CITY OF YORK
LOCAL PLAN
Site Selection Paper Addendum
September 2014

Non-Strategic Site Addendum **Page 19**

SUBMITTED SITE PLAN

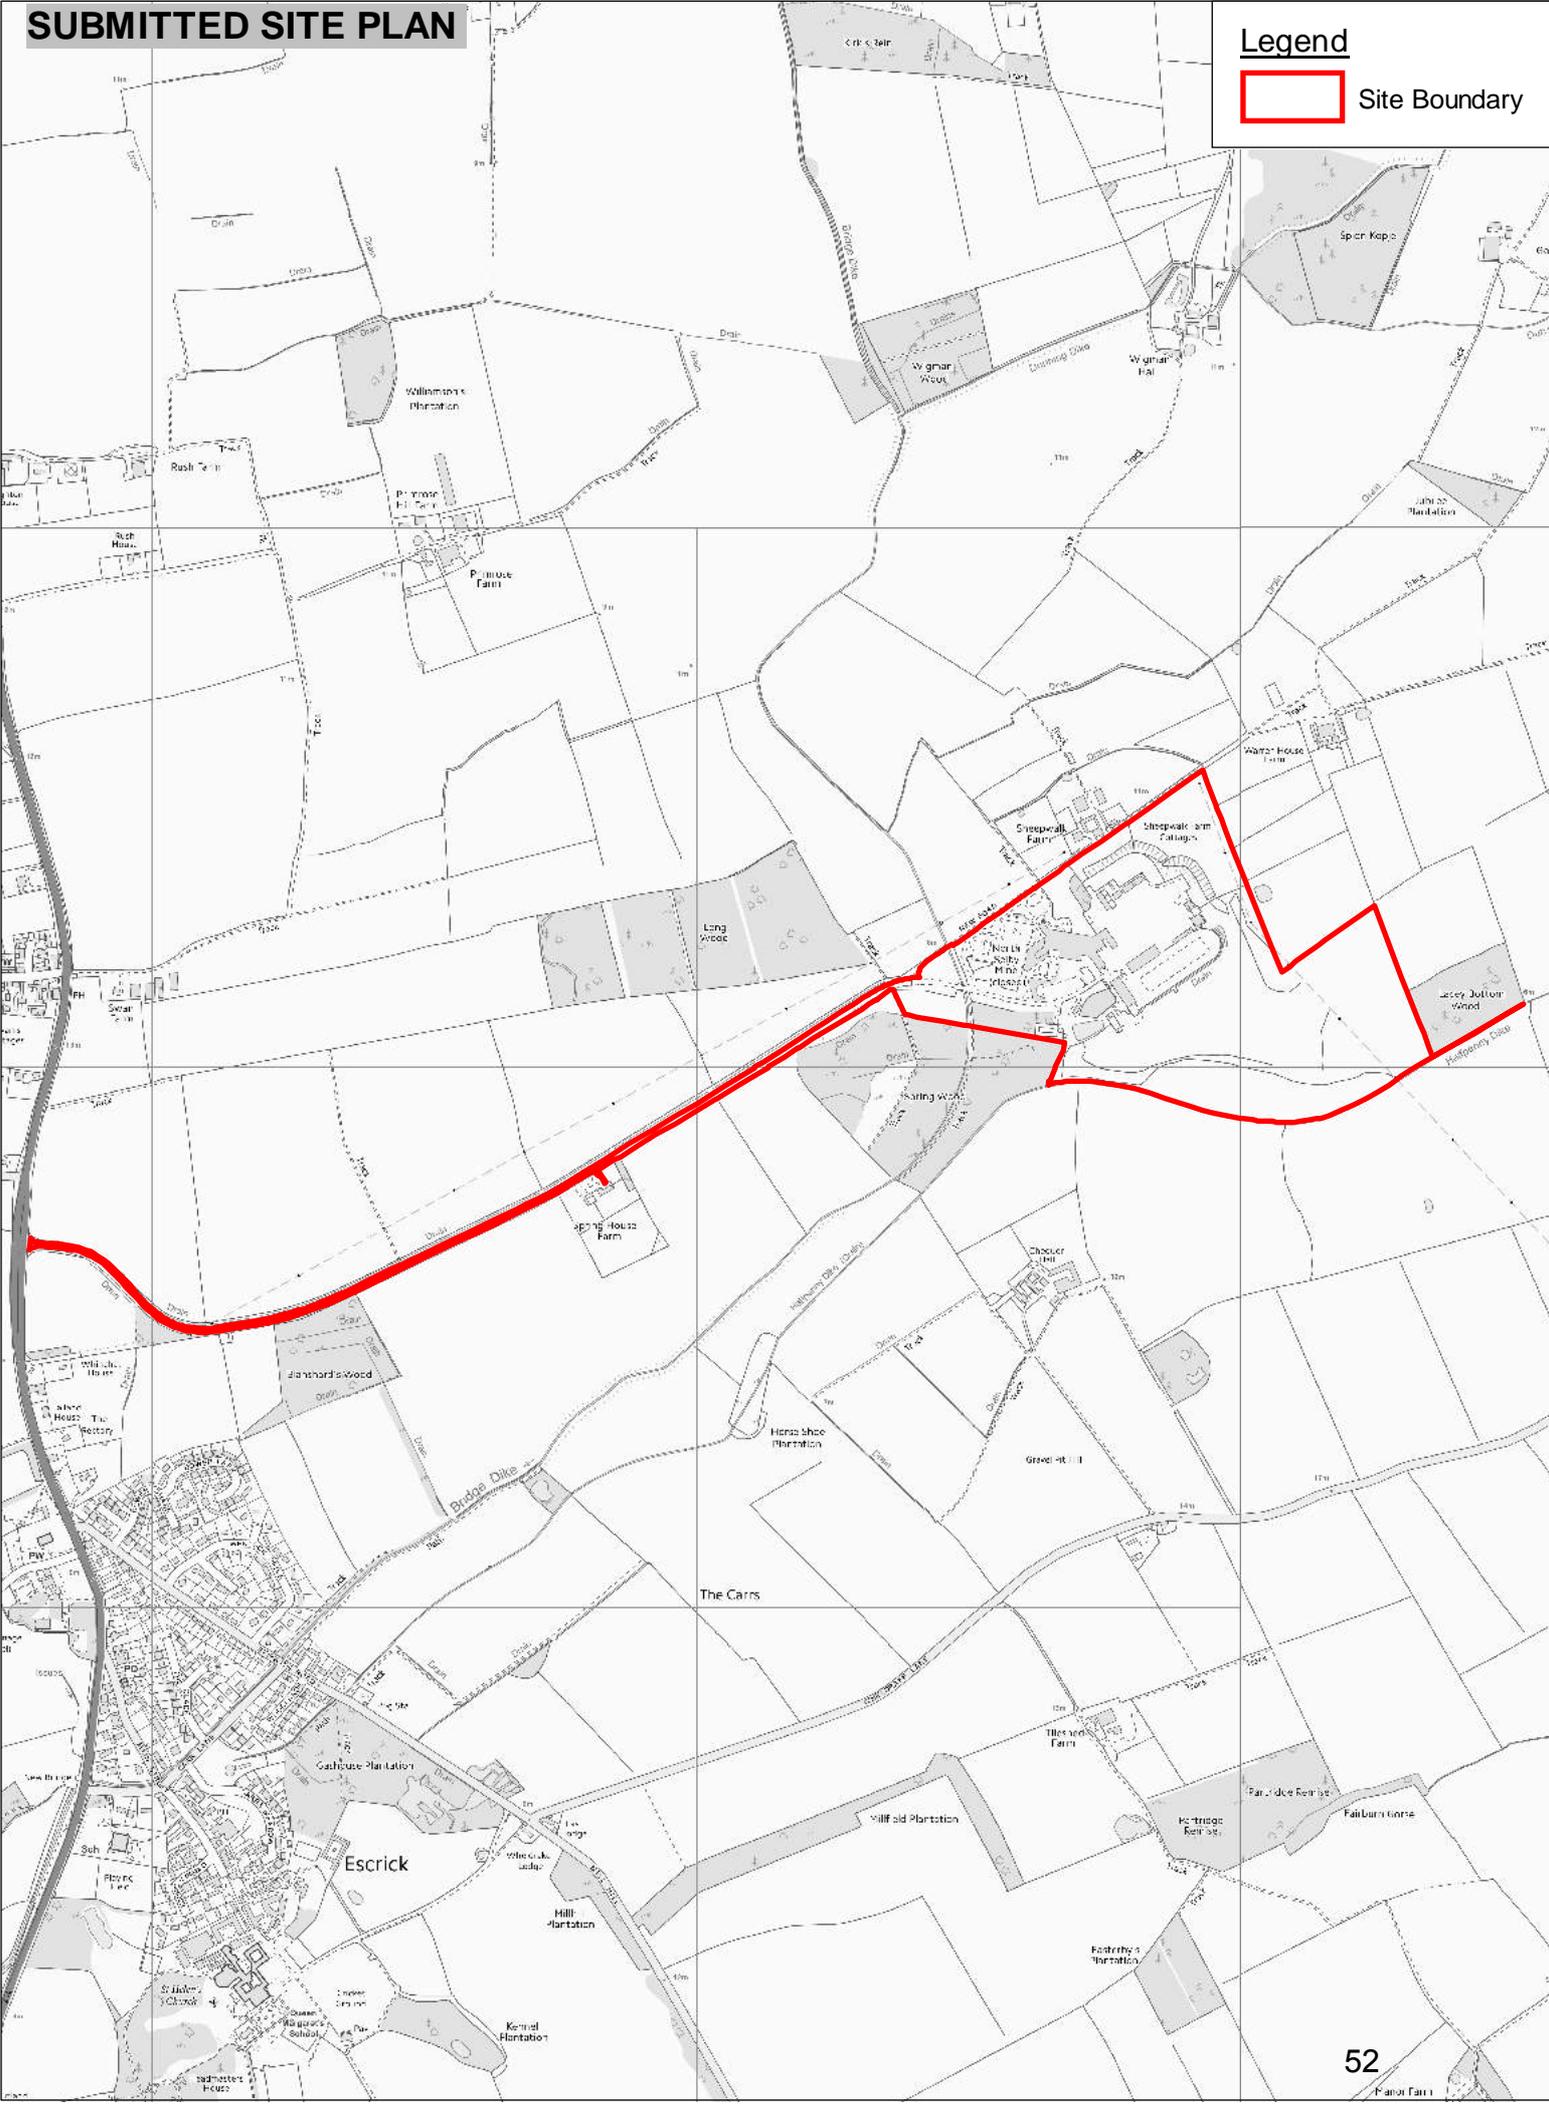
ID Ref:	ID4382
New site ref:	
Original Site Ref Number:	178
Allocation Ref:	
Site Name:	North Selby Mine
Submitted for:	
Agent:	Barton Willmore
Response submitted by:	Liam Tate
On behalf of:	Peel Environmental Management
Additional Evidence Through FSC:	
Summary of Response Received:	Object to FSC which recommends that the site could be accommodated within the general extent of the green belt and therefore specific allocation for RE generation as they requested was not necessary. Consider that the site doesn't fulfil the 5 purposes of greenbelt – its not in open countryside but forms a redundant mine with a clear sense of permanence and physical separation between site and urban edge of York. Its well separated from villages to prevent merging with defensible boundaries (Spring Wood, screening bunds and New Road), does not perform role and function of countryside given its brownfield nature (as agreed in the CYC committee report on application) and is existing development. Would not impact on HC&S of York and is PDL. Committee report also notes 'urbanised character of site. It is considered that the current designation as greenbelt would compromise the future operations of the site and place unnecessary restrictions on its future use

Flooding/Drainage:	
Landscape Comments:	
Ecology Comments:	
Transport Comments:	
EDU comments:	
Open Space Comments:	
Archaeology Comments:	
Retail Comments:	
Proposals Map Action Required:	Show as site within general extent of green belt referenced to Sustainability and Climate Change chapter/policy
Trajectory implications:	N/A
ID:	14
Officer Recommendation:	No change to FSC proposal. It is considered that the uses as granted by the planning permission can be accommodated within the general extent of the greenbelt without compromising the future operation of the business.

SUBMITTED SITE PLAN

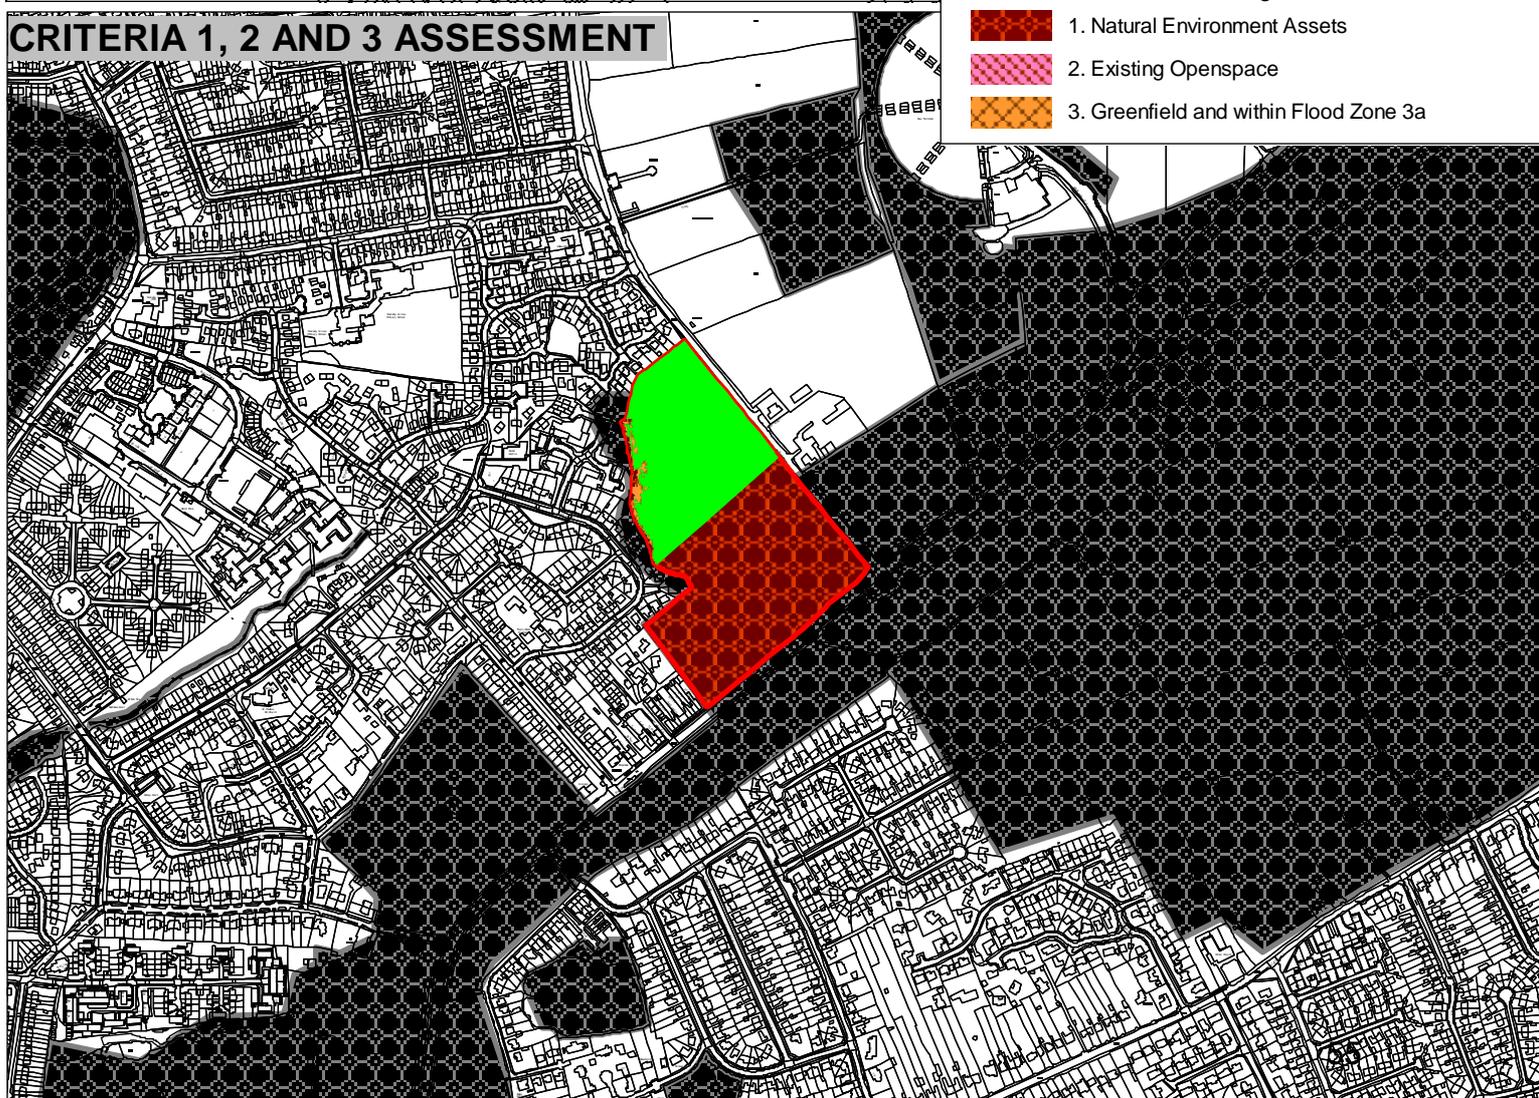
ID Ref:	ID305
New site ref:	
Original Site Ref Number:	180
Allocation Ref:	H50
Site Name:	Malton Road, York
Submitted for:	Housing
Agent:	Taylor Wimpey
Response submitted by:	Russell Hall
On behalf of:	Taylor Wimpy North Yorkshire
Additional Evidence Through FSC:	Yes - Landscape Appraisal (URS)
Summary of Response Recieved:	Part of the original site submission boundary is fails criteria 1 (primary constraints) of the Site Selection methodology as it falls within the HC&S (green wedge) However part of the site falls outside primary constraints and is shown as developable in the FSC so should be allocated. Submitted further landscape evidence URS. Reconsider allocating the part of the site which is outside primary constraints.
Flooding/Drainage:	No further comments in addition to FSC. The revised Lidar data submitted as part of the Preferred Options consultation has been accepted. Parts of the site are within flood zones 1,2,3a and 3b which would reduce the developable area. AMBER

Landscape Comments:	The green wedge at the southern edge of the site should be maintained as it is important to the context and setting of the City and provides connectivity to the adjacent farmland. Narrowing of the green wedge would have a negative effect in this location as it is intrinsic to York's urban form. Further evidence submitted at FSC has been reviewed and does not change the view with regards the southern part of the site that is within the HC&S (Green Wedge). However it is considered that development of the part of the site to the north which is outside of the HC&S does offer some potential and is not critical to the openness and setting of York. The site is therefore considered potentially suitable for development subject to approval of masterplan and appropriate landscaping scheme. AMBER
Ecology Comments:	No additional comments to FSC. AMBER
Transport Comments:	No further comments in addition to FSC. AMBER

EDU comments:	N/A
Open Space Comments:	No additional comments to FSC. GREEN
Archaeology Comments:	No additional comments to FSC. GREEN
Retail Comments:	N/A
Proposals Map Action Required:	Add to proposals map
Trajectory implications:	Add site to trajectory (H50)
ID:	15
Officer Recommendation:	Part of the site to the southern edge fails primary constraints (criteria 1) as it falls within a green wedge. This should be retained as it is important to the context and setting of the city and provides connectivity to the adjacent farmland. It is considered that narrowing of the green wedge in this location would have a negative impact. Further evidence submitted

at FSC has been reviewed and does not change the view with regards the southern part of the site that is within the HC&S (Green Wedge). However it is considered that development of the part of the site to the north which is outside of the HC&S does offer some potential and is not critical to the openness and setting of York. The site is therefore considered potentially suitable for development subject to approval of masterplan and appropriate landscaping scheme. It is considered that the part of the site that falls outside the primary constraints should be allocated for housing.

SUBMITTED SITE PLAN

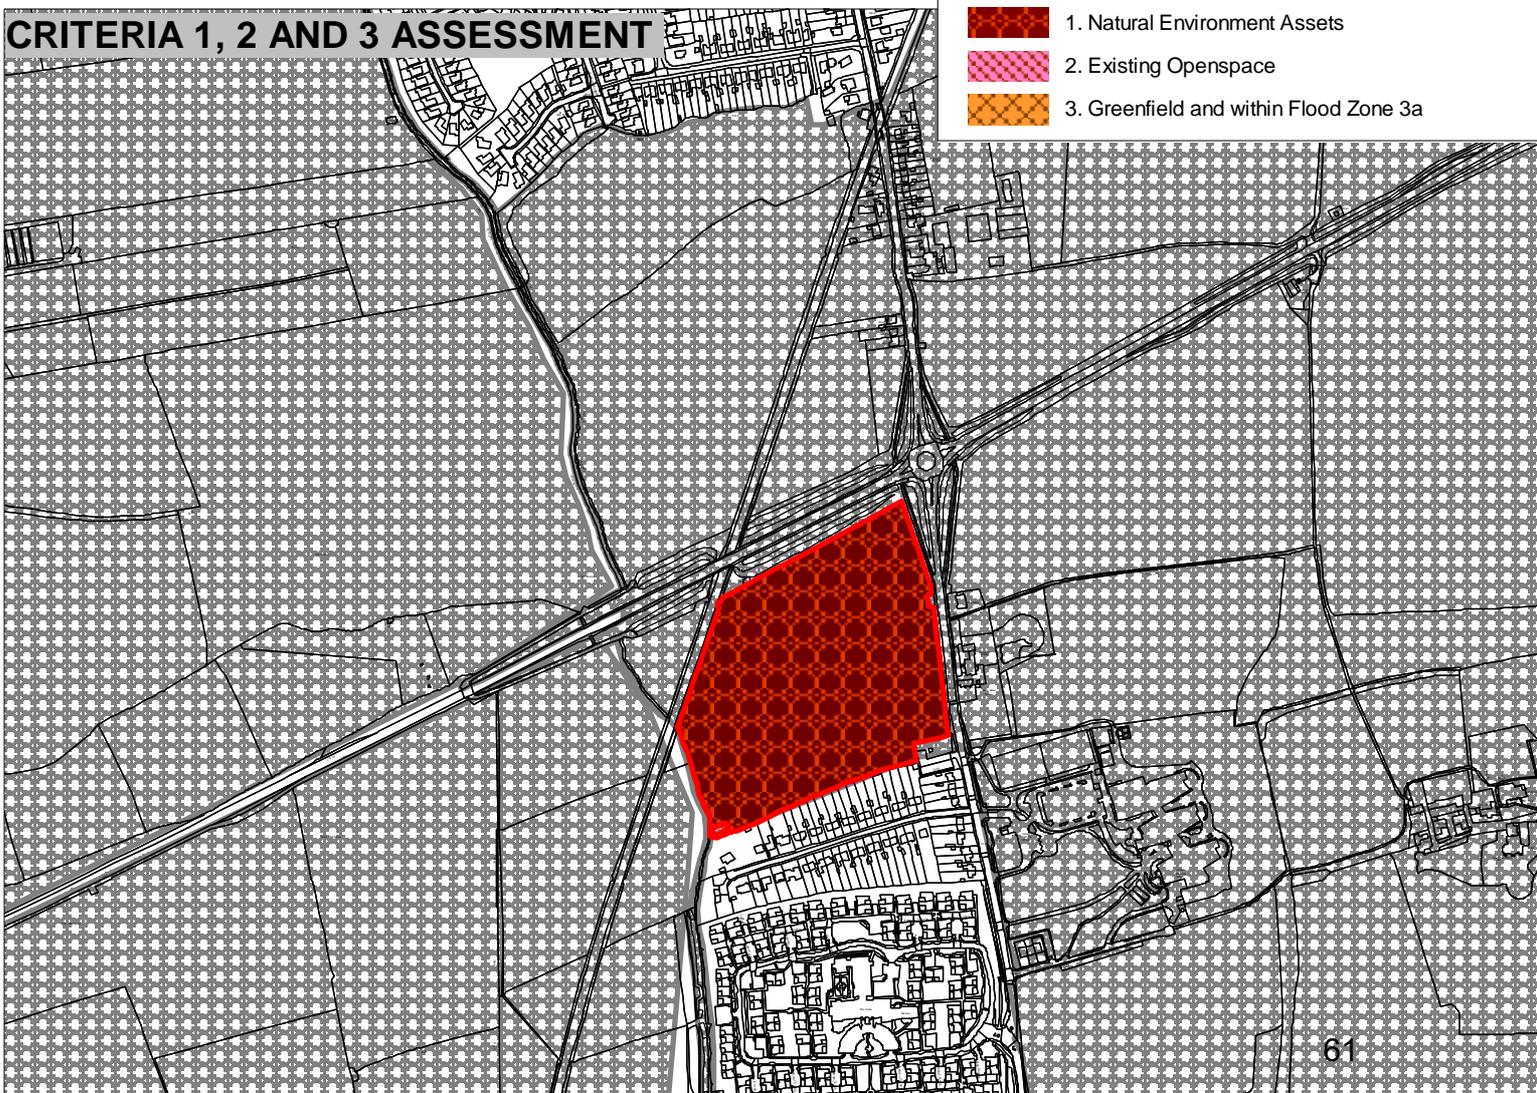
ID Ref:	ID146
New site ref:	
Original Site Ref Number:	184
Allocation Ref:	N/A
Site Name:	Land to the South of A1237
Submitted for:	Housing
Agent:	Directions planning

Response submitted by:	Directions planning
On behalf of:	JRHT
Additional Evidence Through FSC:	Yes - Landscape Appraisal
Summary of Response Recieved:	Site failed criteria 1 in SSP and FSC as within area of coalescence. Reconsider for housing (50%affordable) or consider for safeguarding. Submitted further evidence - greenbelt appraisal. Consider that not all the land required to prevent coalescence between new earswick and haxby. Don't consider the site is required because sufficient gap would still be maintained between the two settlement to ensure separation and development of the site would not inhibit the openness of the wider area.
Flooding/Drainage:	N/A
Landscape Comments:	Landscape evidence submitted through FSC has been considered. It is felt there are some gaps in the analysis submitted including those of assessing key views from the west. It is still considered despite the further evidence that the remaining open land between New Earswick, the A1237 and Haxby is critical in preventing coalescence and for the setting of the city with regards to the physical separation from the A1237. The introduction of a built form in this location, whilst acknowledging this could be partly mitigated through landscaping, would introduce solidity in a currently fluid landscape through the introduction of building road and lighting. This is considered unacceptable and remains a showstopper to development.RED

acknowledging this could be partly mitigated through landscaping, would introduce solidity in a currently fluid landscape through the introduction of building road and lighting. This is considered unacceptable and remains a showstopper to development whether allocation of safeguarded landREJECT - NO CHANGE
